# Ecosystems Strategies, Inc.

**Re: 12CBCP017X**  
**4-12 Gouverneur Place**  
**Remedial Action Work Plan (RAWP) Stipulation List**  
**ESI File: WB08037**

## **Stipulation List**

**End-Point Sampling Plan**

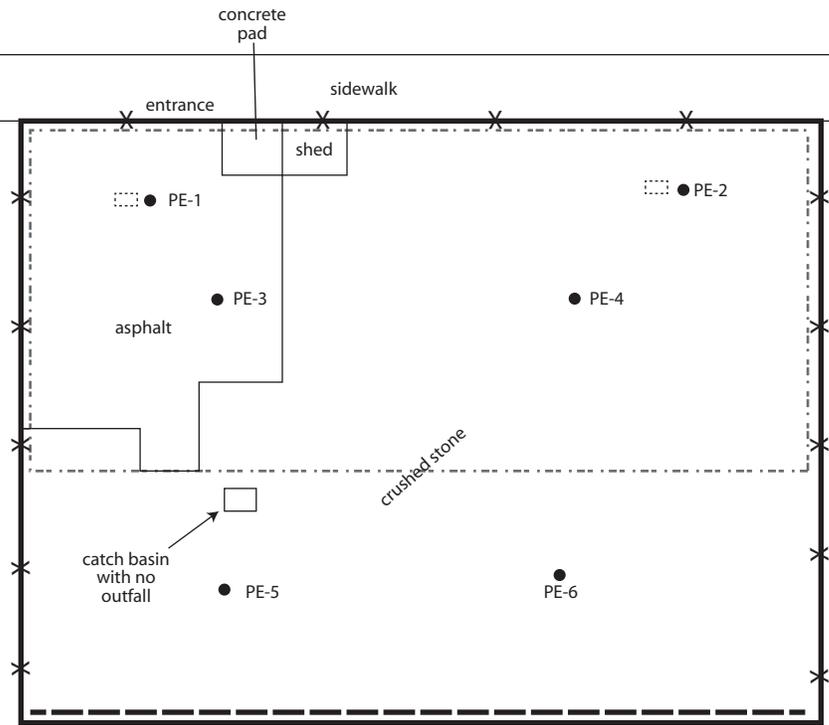
- Site conditions may warrant the collection/analysis of additional samples (e.g., presence of limited contamination). Any additional sampling will be represented in the RAR.

## Schematic Layout of SSDS

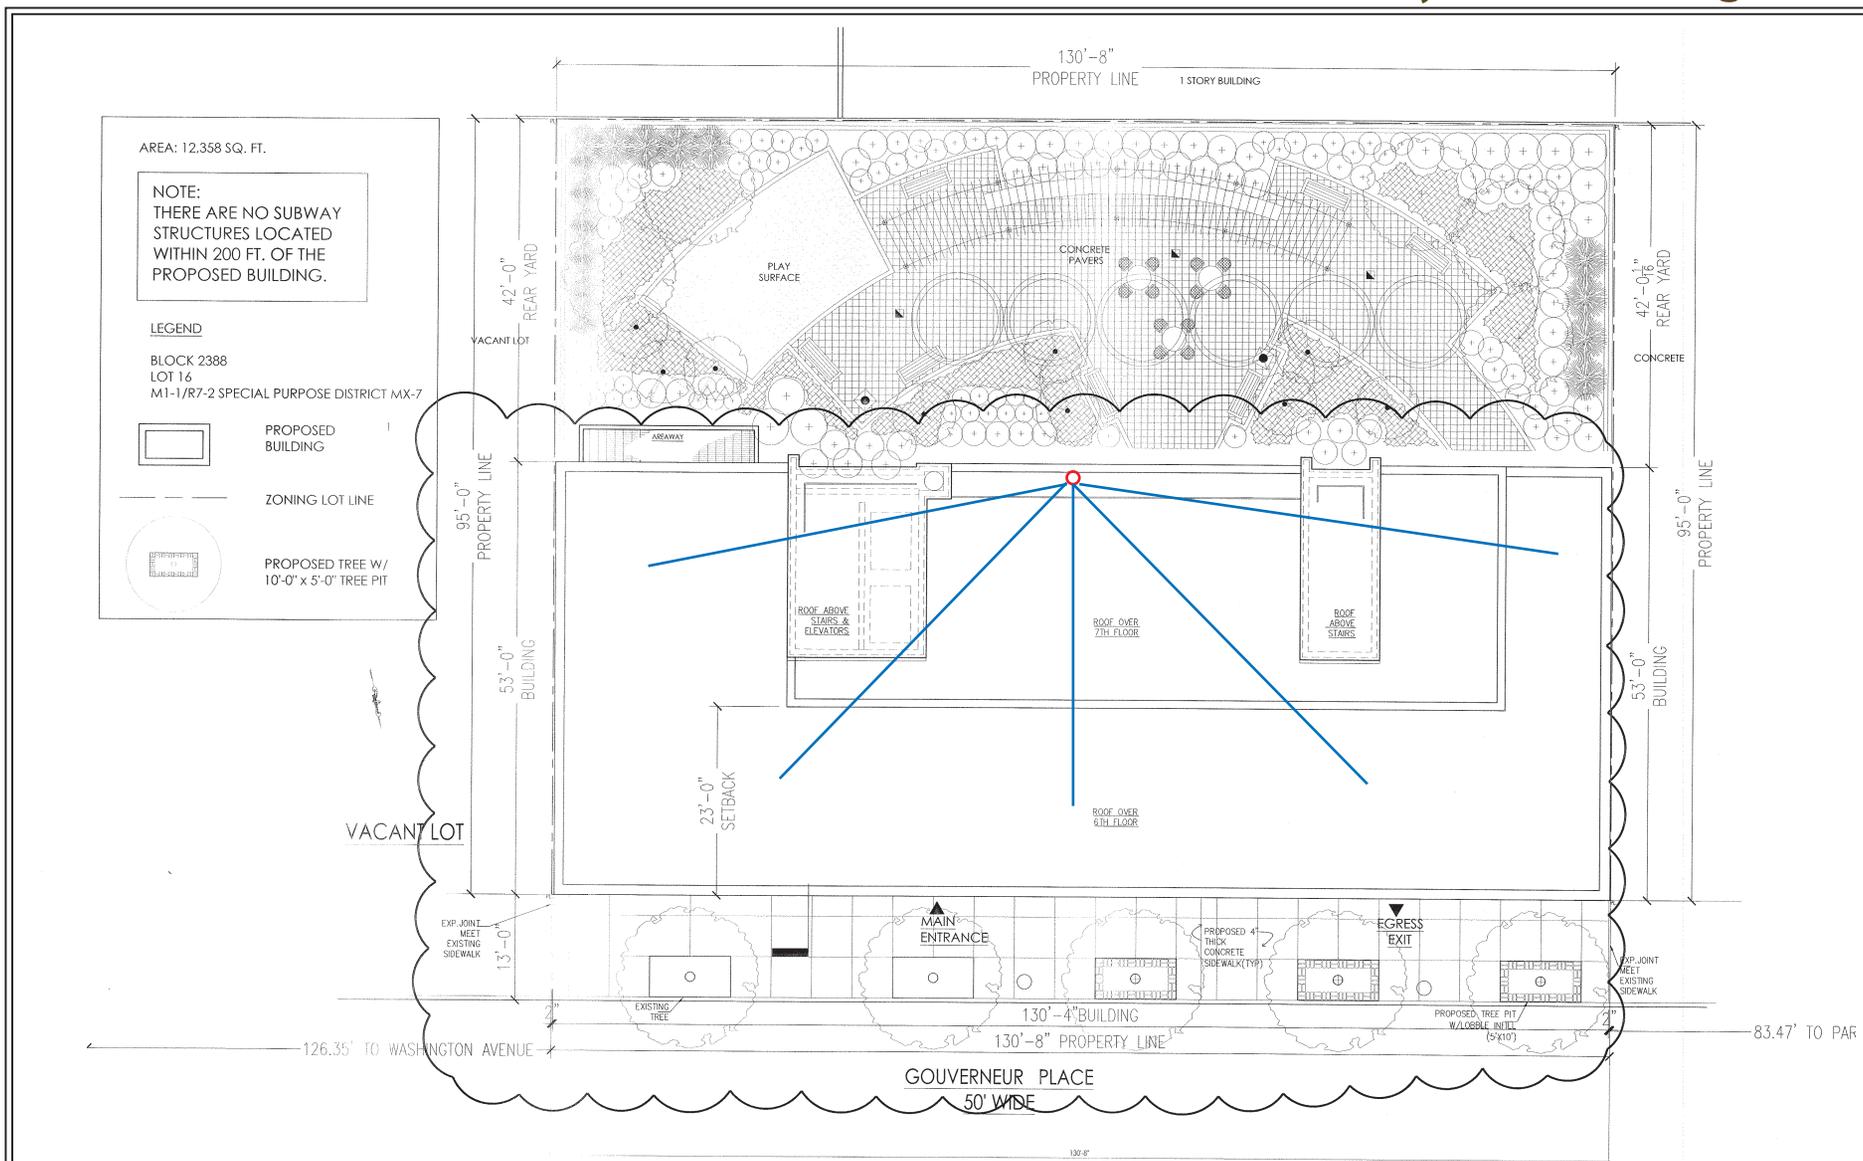
3. The remedy will include installation of a passive sub-slab depressurization system (SSDS) beneath the building slab. The Sub Slab Depressurization System (SSDS) will consist of subslab PVC piping placed in the subgrade gravel (beneath the vapor barrier referenced in Paragraph 4, below), plumbed to a roof-top vent. The SSDS will be constructed of schedule 80 PVC (3" outer diameter) piping under the slab connected to black iron (or equivalent) piping above-grade and then manifolded to a single roof top emission point. The subgrade piping will be perforated at all locations prior to the vertical risers, as shown on the Schematic Layout of SSDS in **Addendum 3**. The exact locations may change based on site conditions. The pipe will be grouted at the surface to improve the system's vacuum. Drawings of the SSDS as provided by the project engineer are included as **Addendum 3**.

<b>Schematic of Vapor Barrier</b>	
4-12 Gouverneur Place Bronx, New York	
ESI File: WB08037	
February 2012	Addendum 5

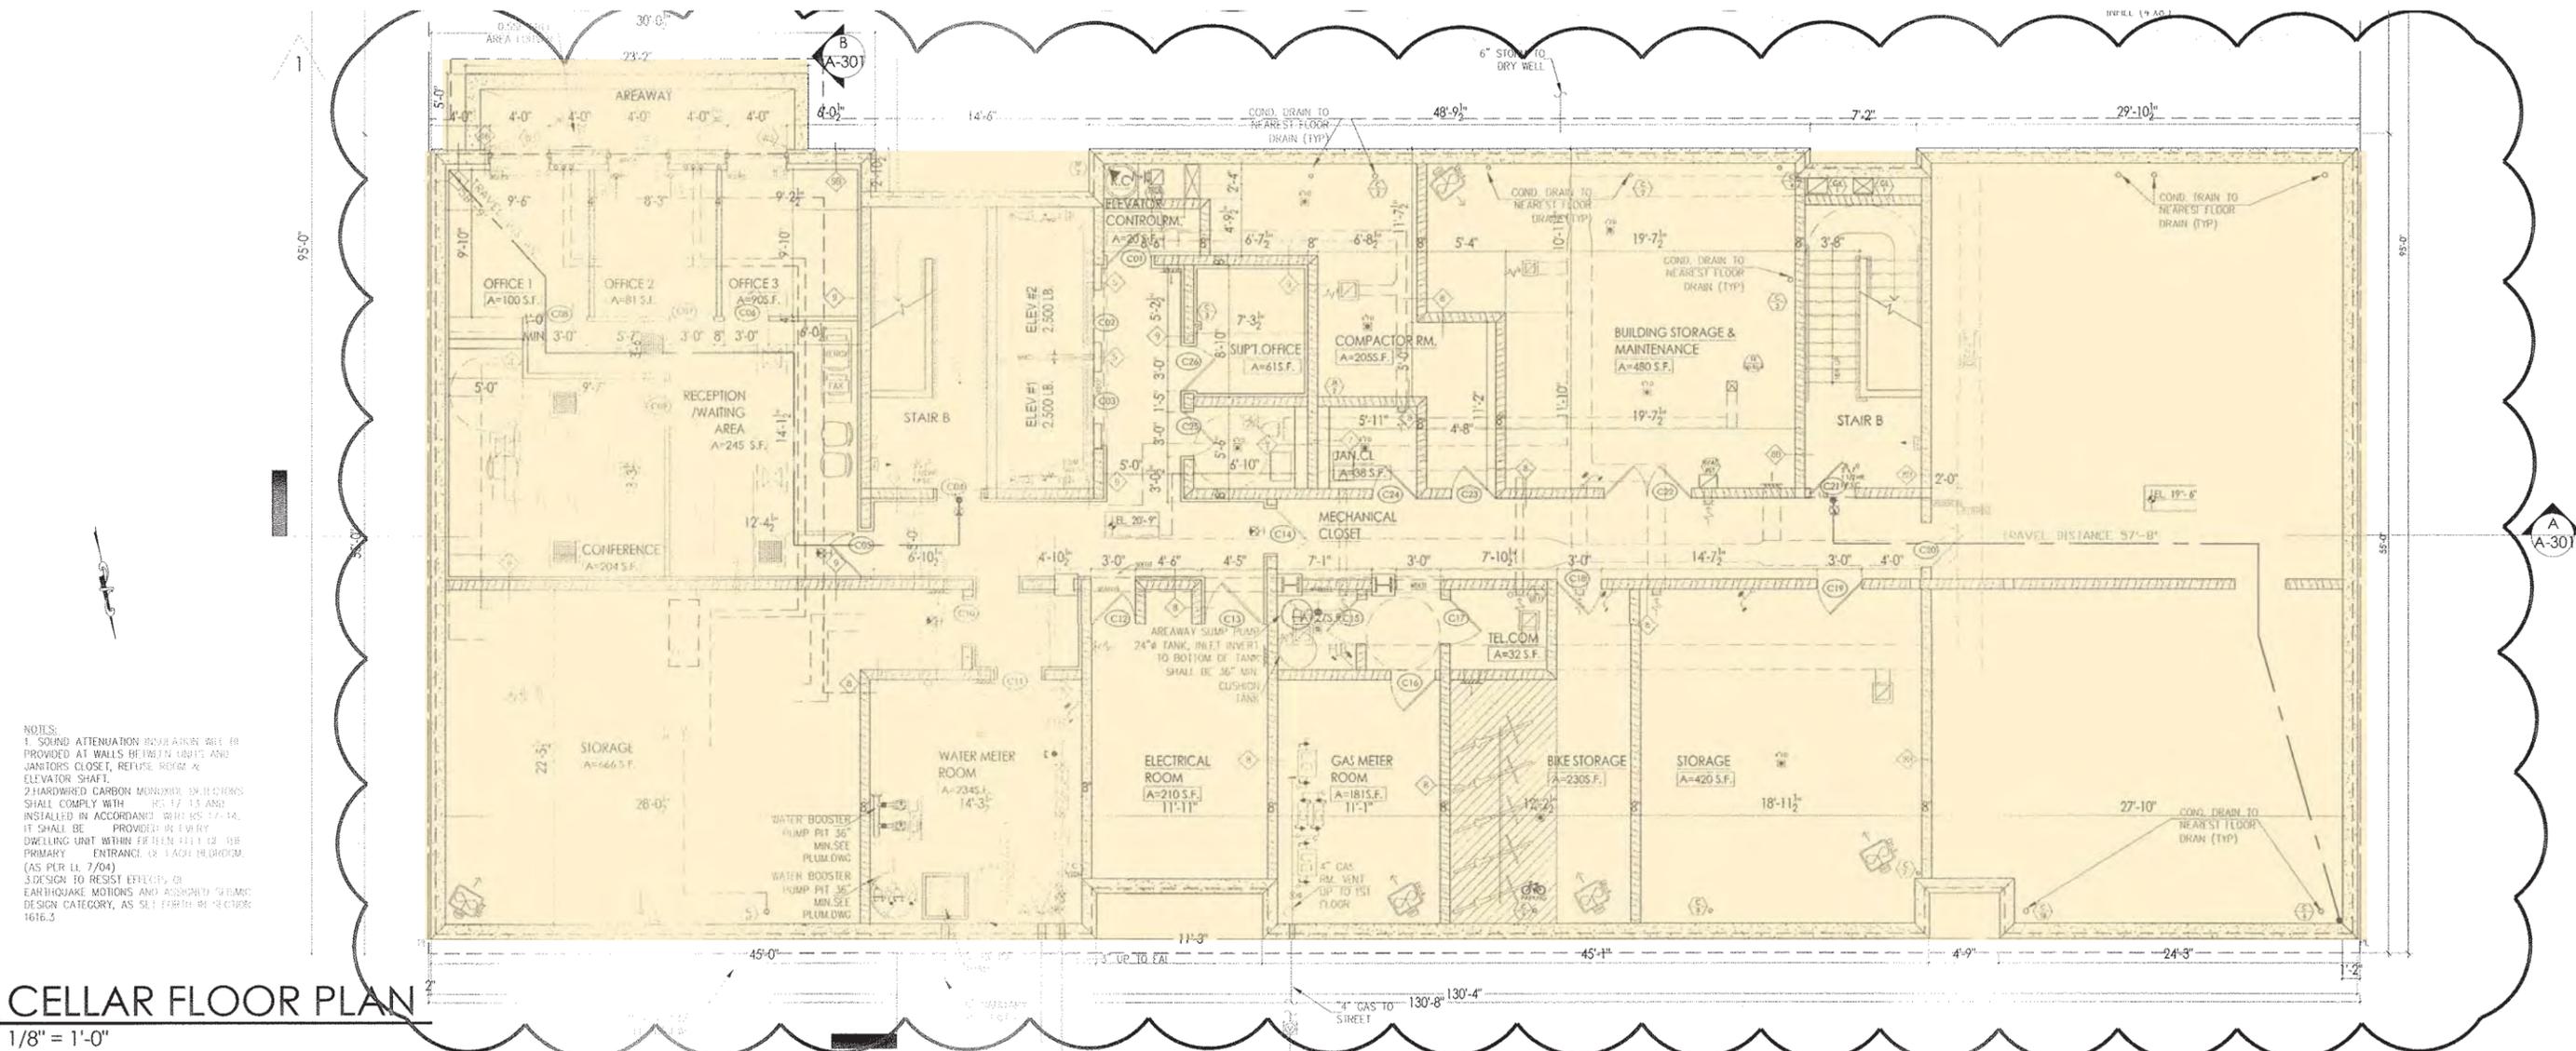
4. The vapor barrier planned for this project is a VaporBlock 20 Plus with an effective thickness of 20 mil barrier to be installed beneath the building slab. Relevant information on the vapor barrier is provided in **Addendum 4**.

5. A schematic drawing of the installation of the vapor barrier (including installation guidelines as provided by the manufacturer) is attached in **Addendum 5**.
